RENESAS TECHNICAL UPDATE

Product Category	MPU & MCU	Document No.	TN-16C-A197A/E	Rev.	1.00
Title	Errata to R32C/157 Group Hardware Manual		Information Category	Technical Notification	
Applicable Product	R32C/157 Group	Lot No.	Reference Document	R32C/157 Group Hardware Manual Rev. 1.03 (REJ09B0507-0103)

This document describes corrections to the R32C/157 Group Hardware Manual, Rev. 1.03.
The corrections are indicated in red in the list below.

Figure 7.1 Clock Generation Circuitry

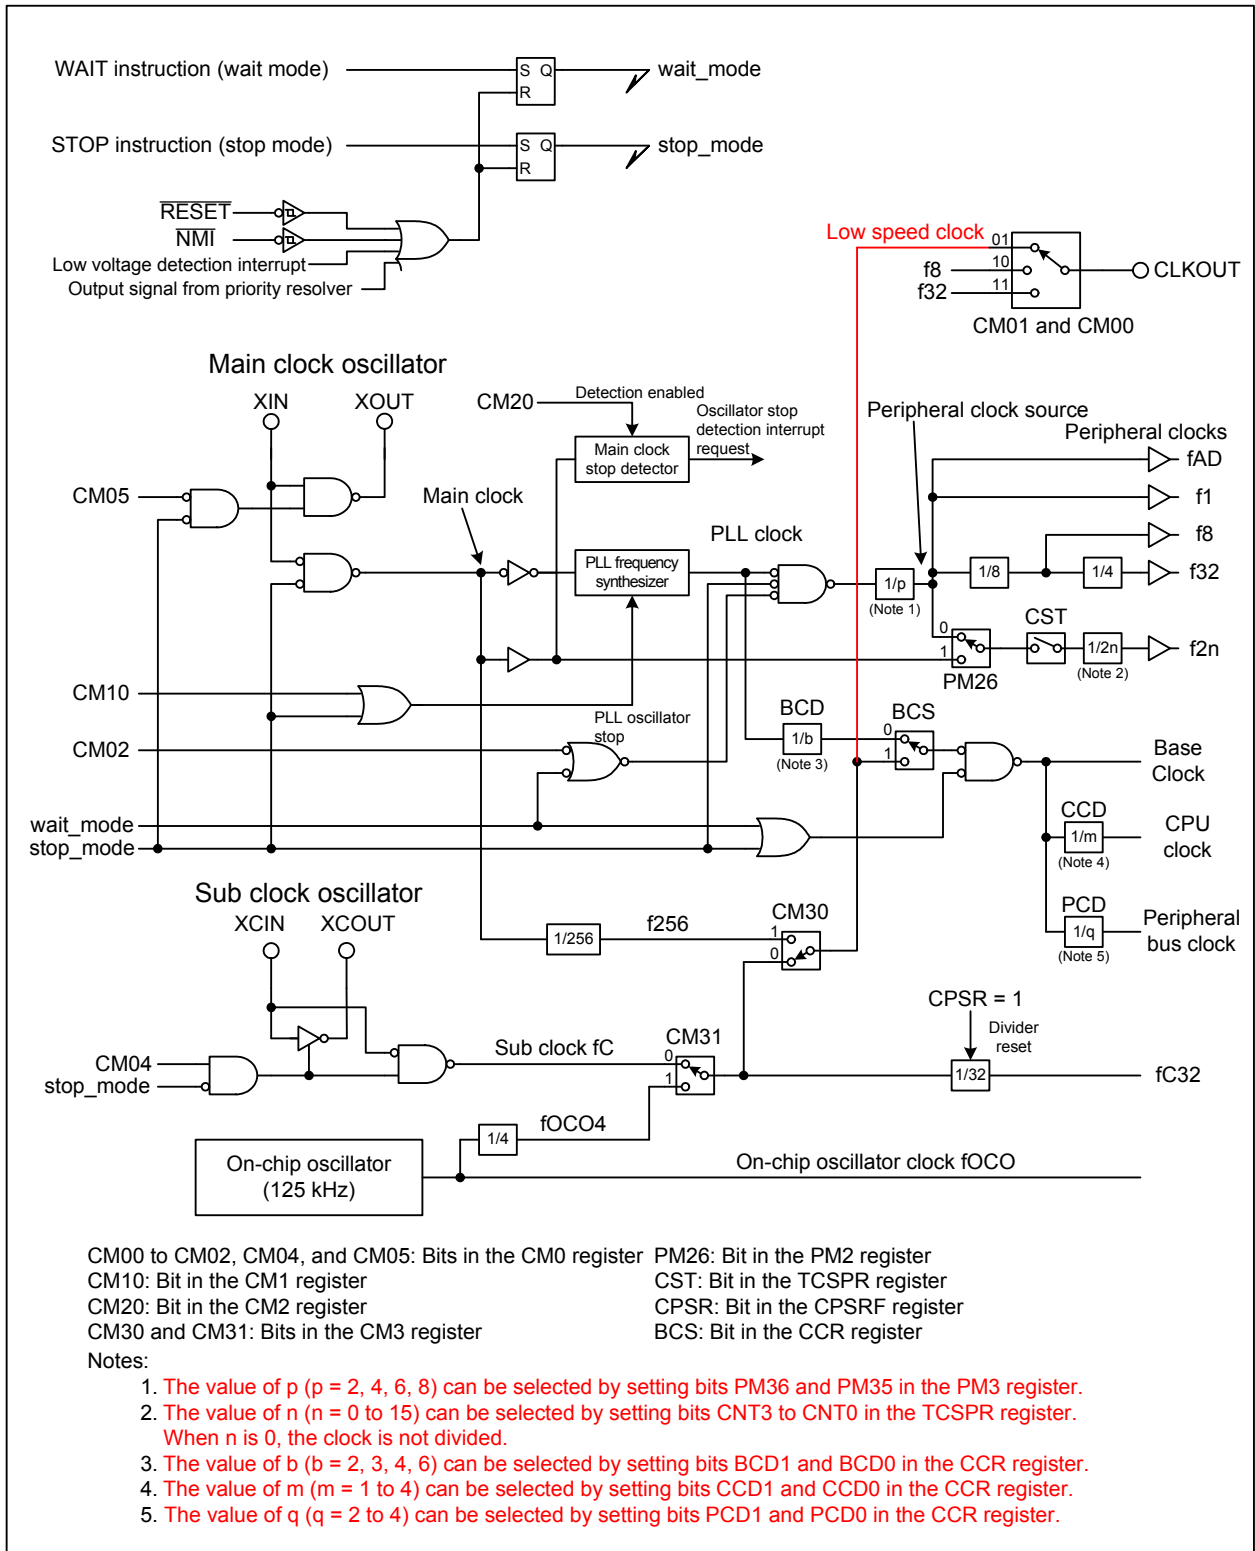
•Page 104 of 636, Figure 7.1 is corrected as follows:

Figure 7.20 State Transition (when the on-chip oscillator clock is used)

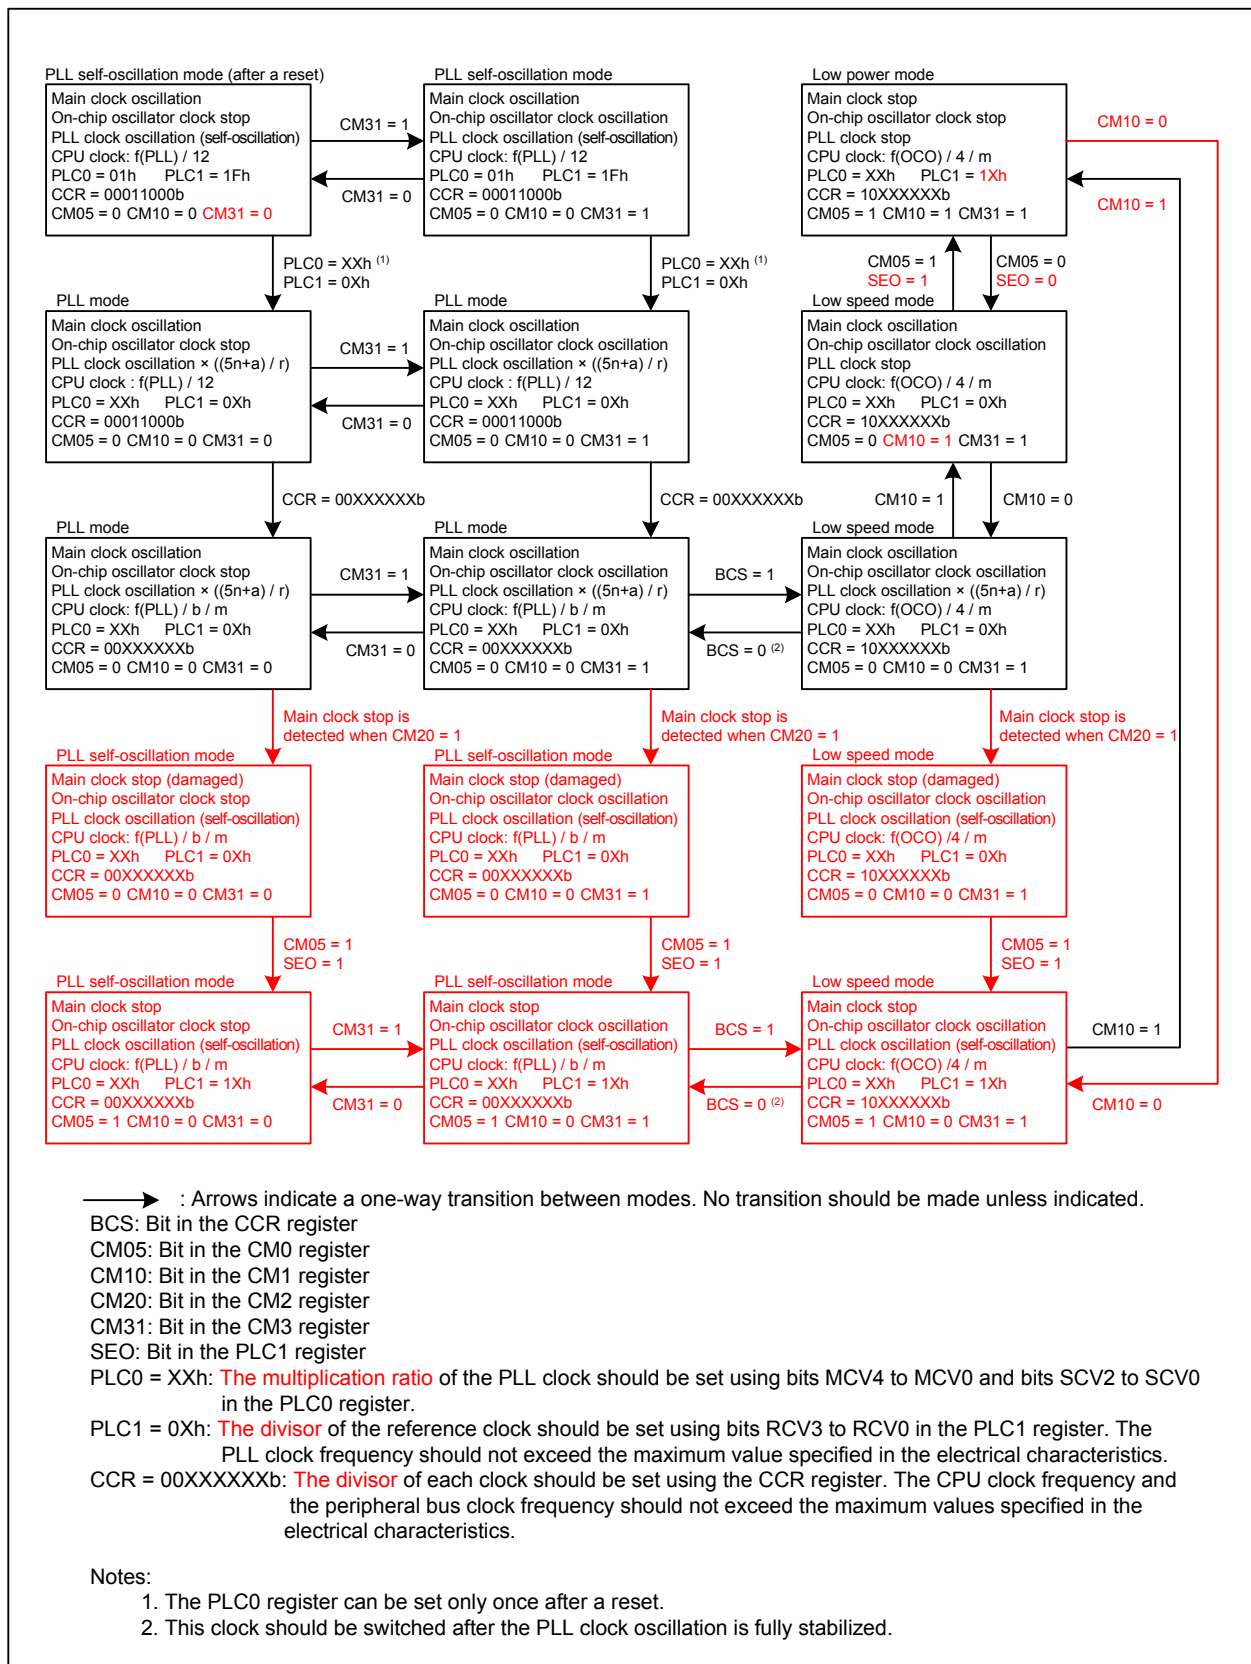
•Page 124 of 636, descriptions “CM31 = 1” in the first row and “CM10 = 0” in the second row in Figure 7.20 are corrected, and the state transition is modified as follows:

(Note 3 “The CM05 bit is not set to 1 when an oscillator stop is detected through the oscillation stop detector.” is deleted from Figure 7.20)

Figure 10.8 Priority Resolver

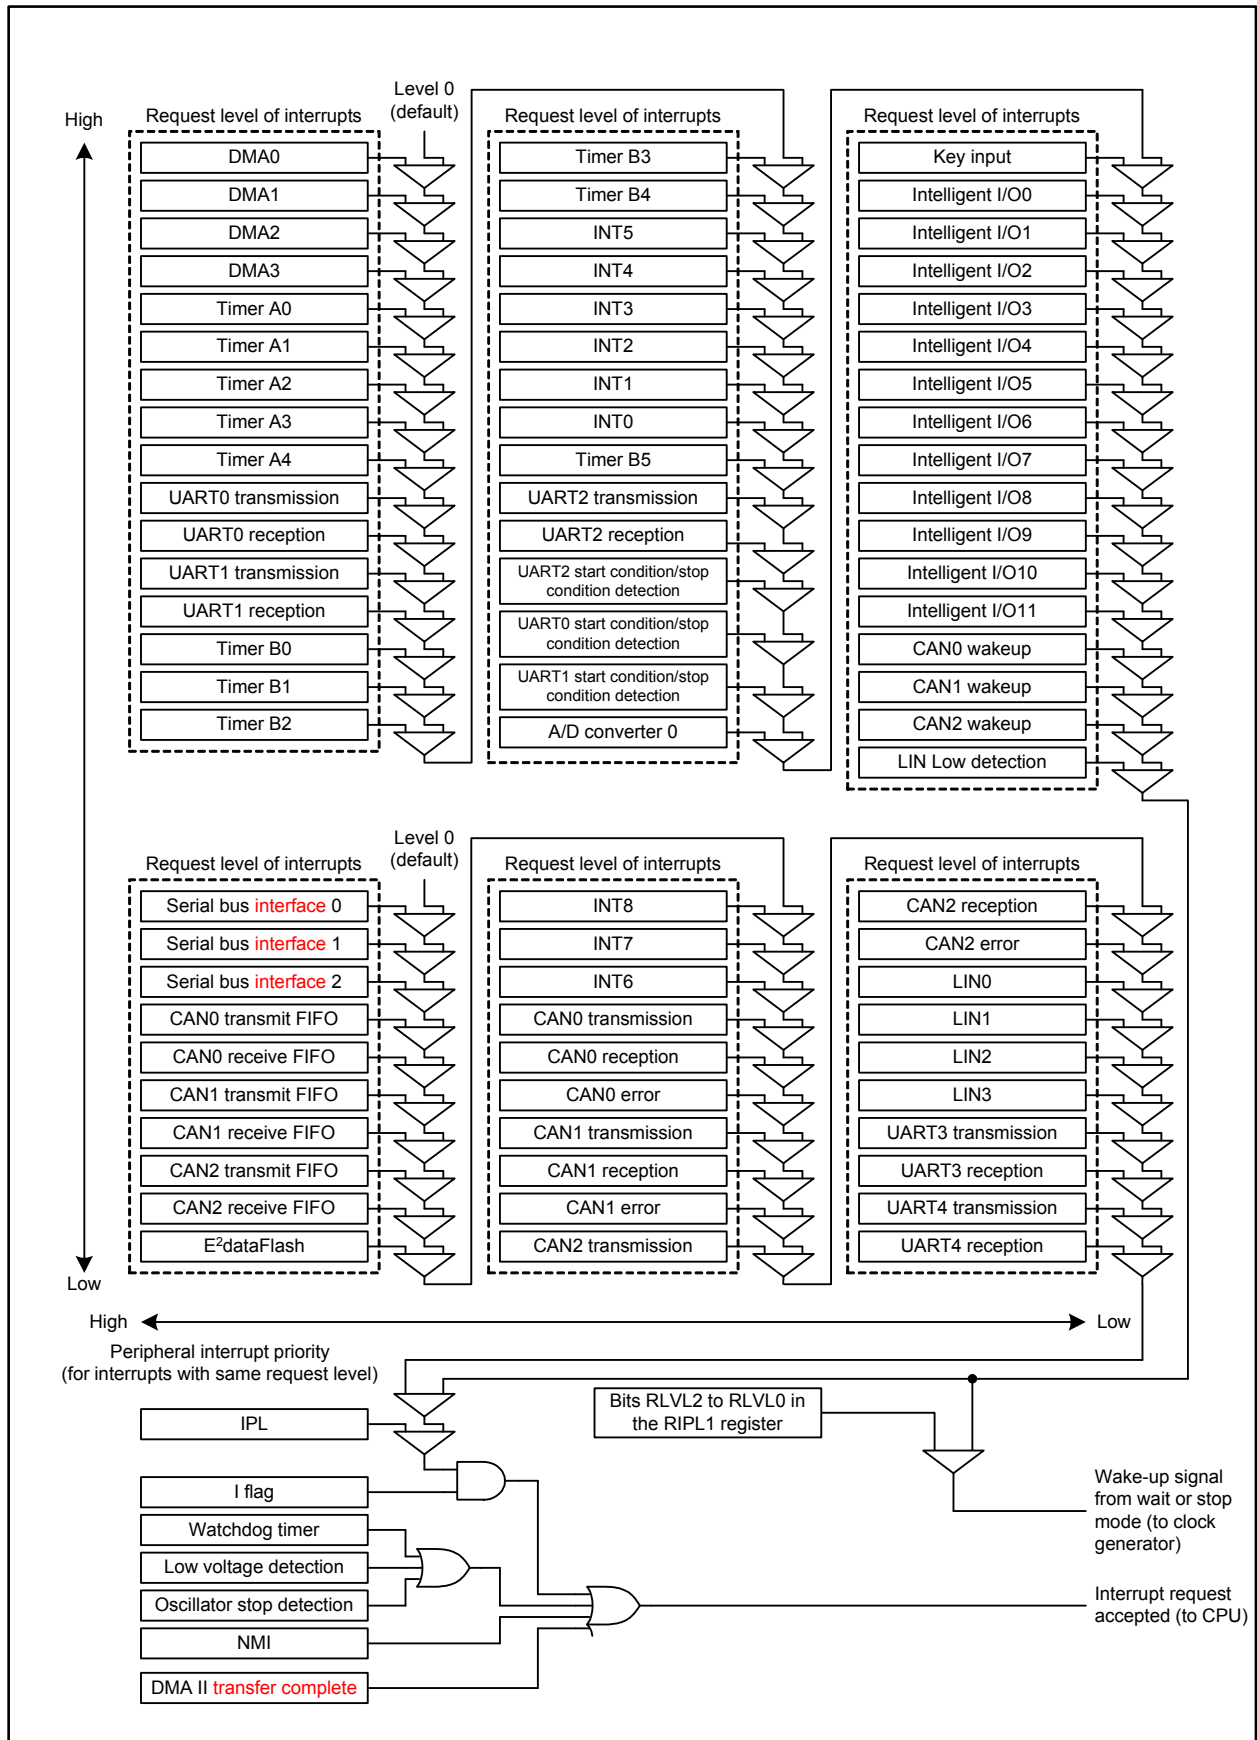
•Page 156 of 636, Figure 10.8 is corrected as follows:

(Description “Bits RLV2 to RLV0 in the RIPL2 register” and associated signal lines are deleted from Figure 10.8)

Figure 15.2 Timer B Configuration

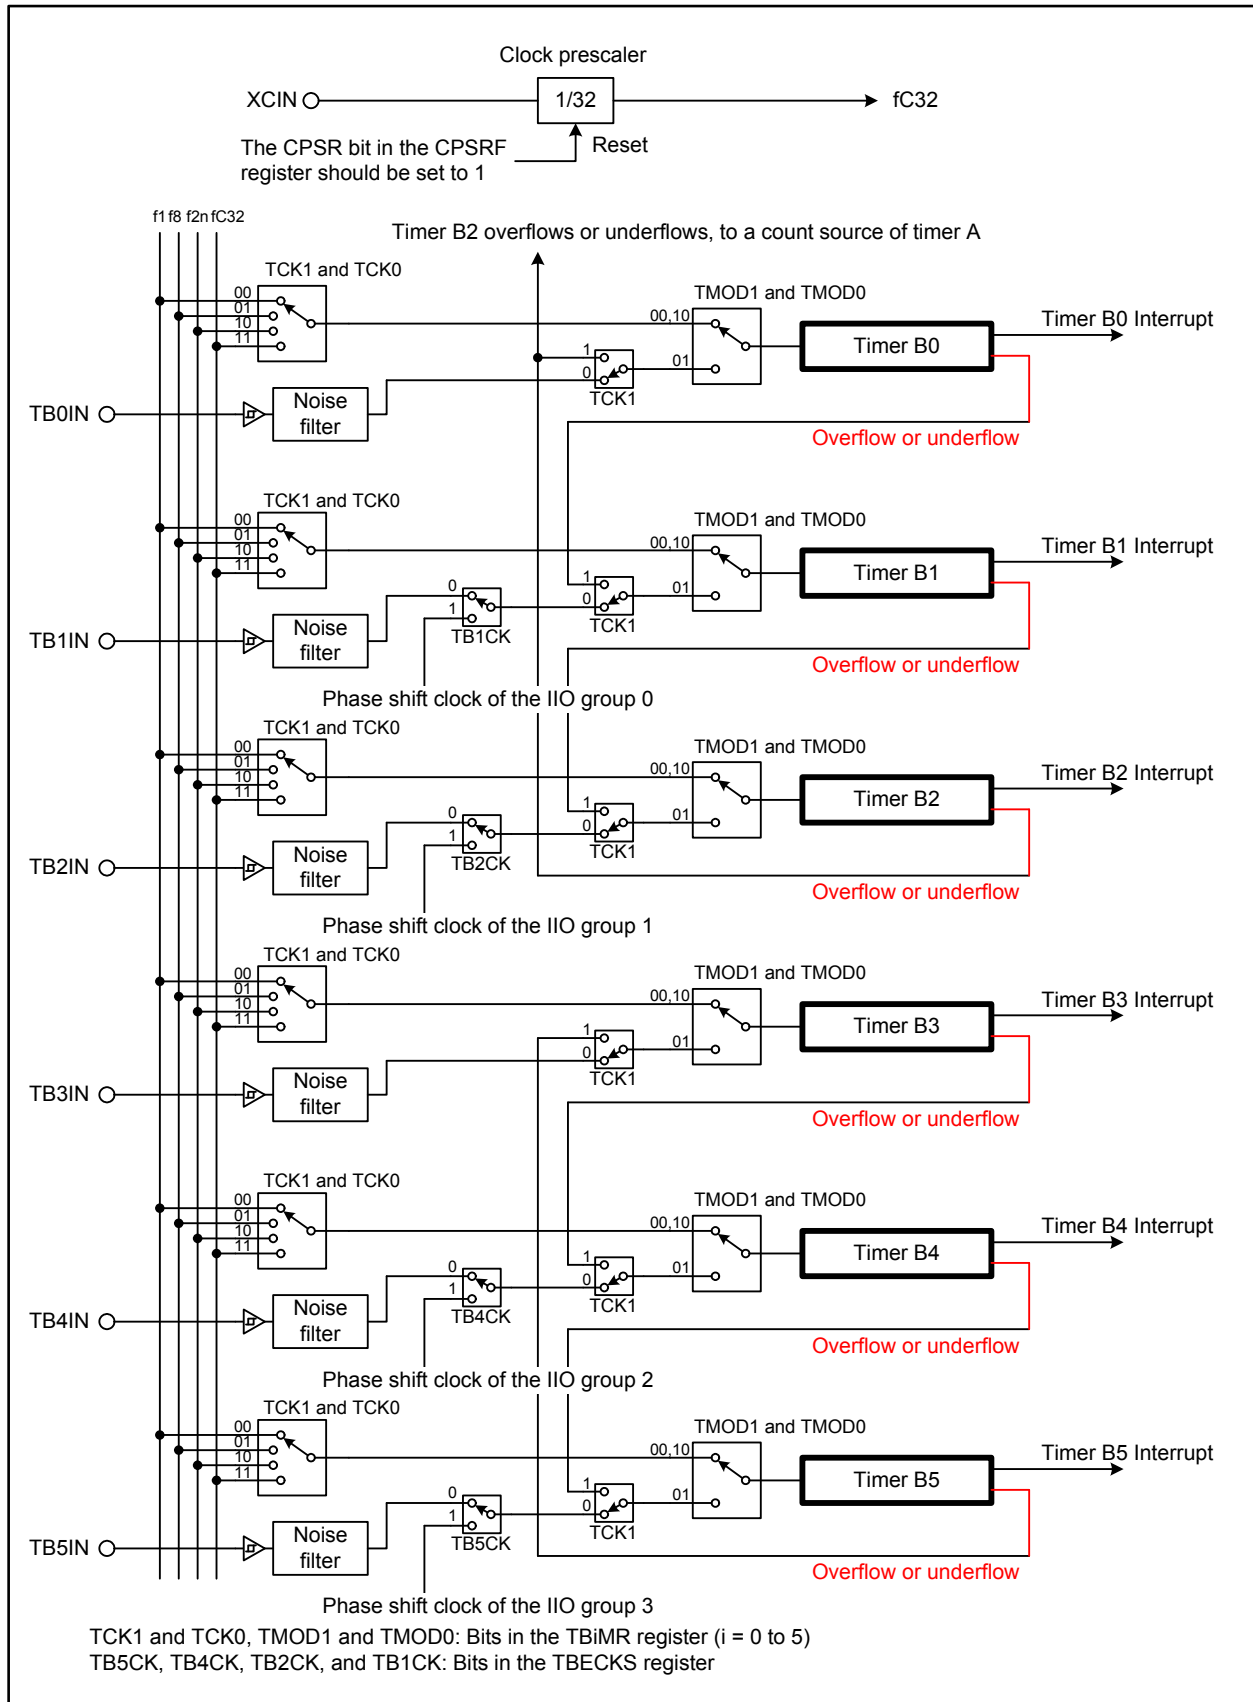
•Page 198 of 636, Figure 15.2 is corrected as follows:

Figure 24.30 Example of Setting Before Transition to Wait Mode

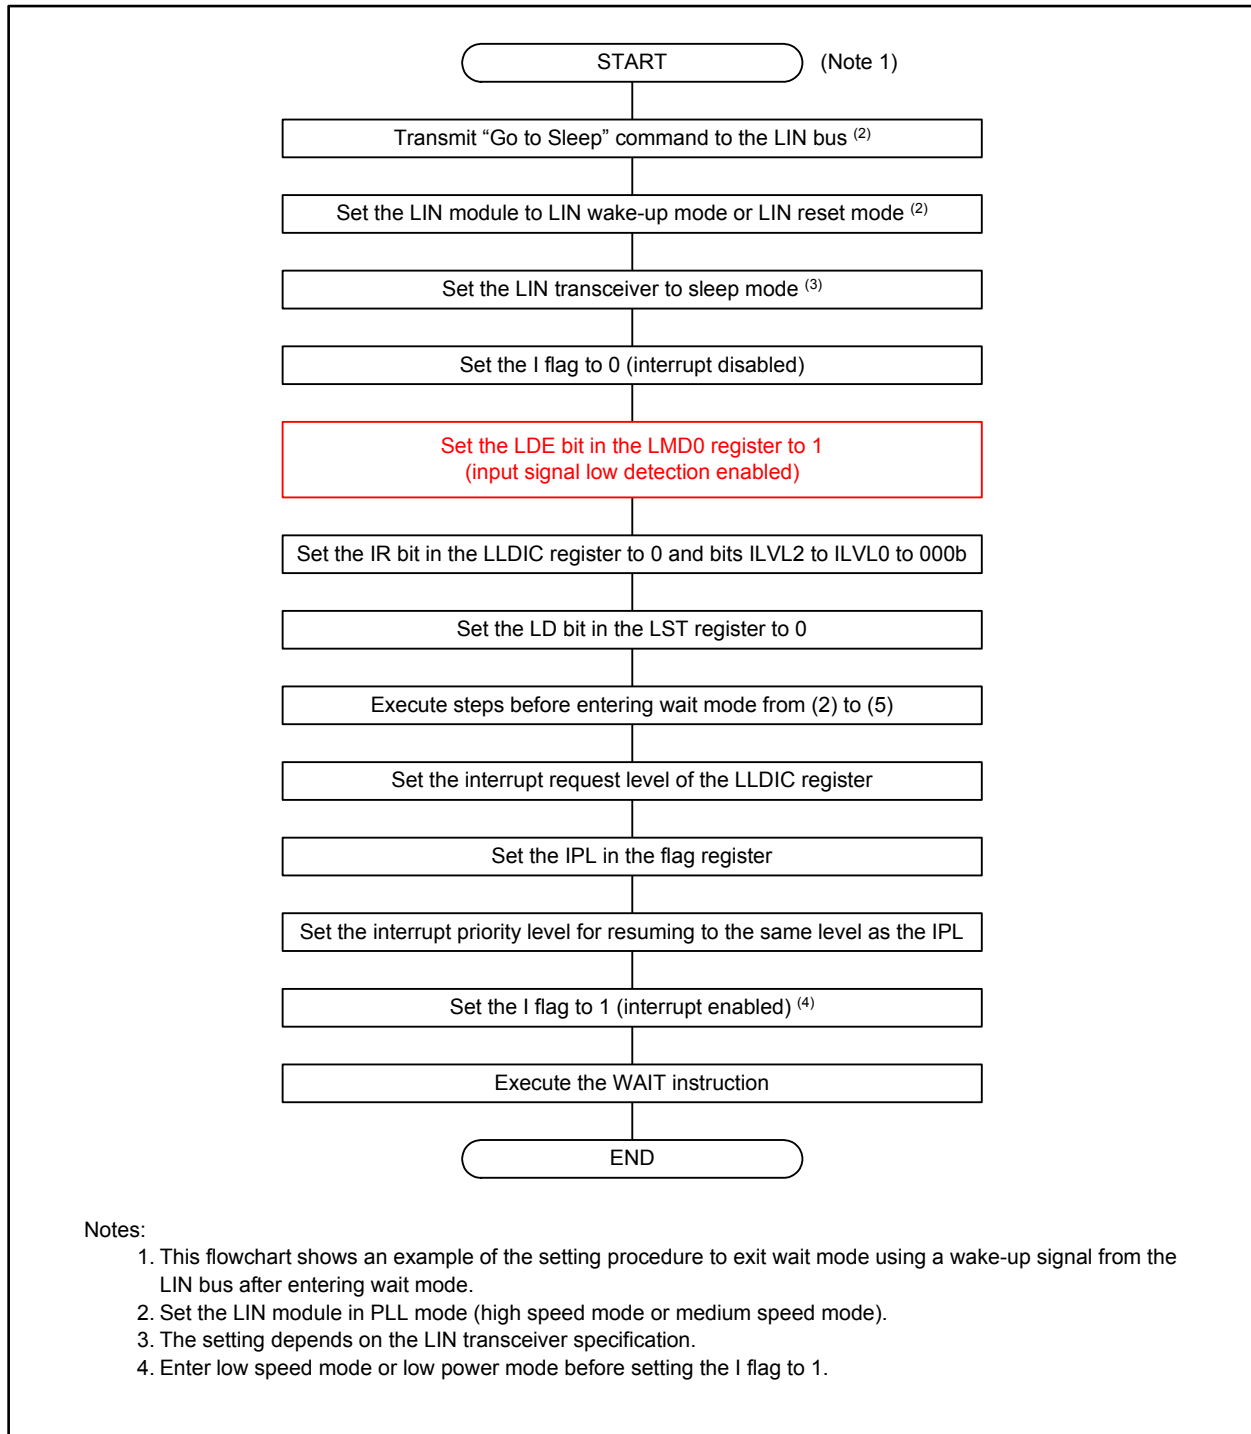
•Page 432 of 636, Figure 24.30 is corrected as follows:

Figure 24.32 LINj Interrupt Block Diagram (j = 0 to 3)

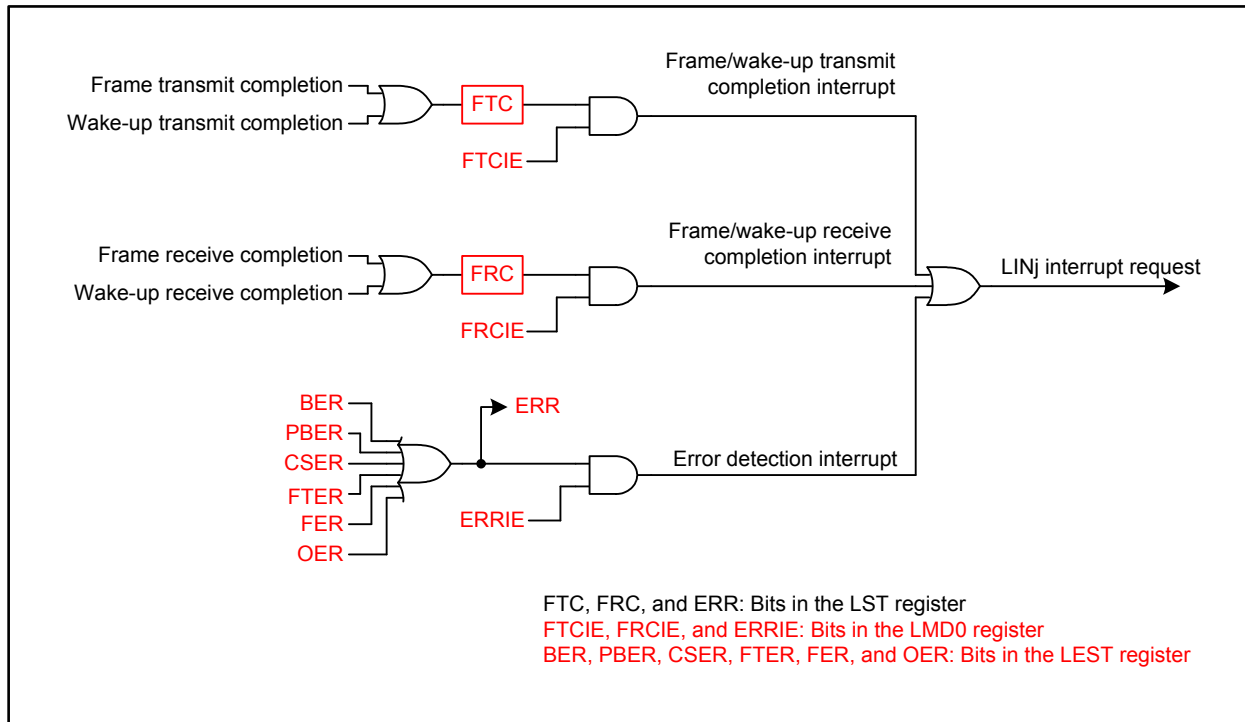
- Page 436 of 636, Figure 24.32 is corrected as follows:
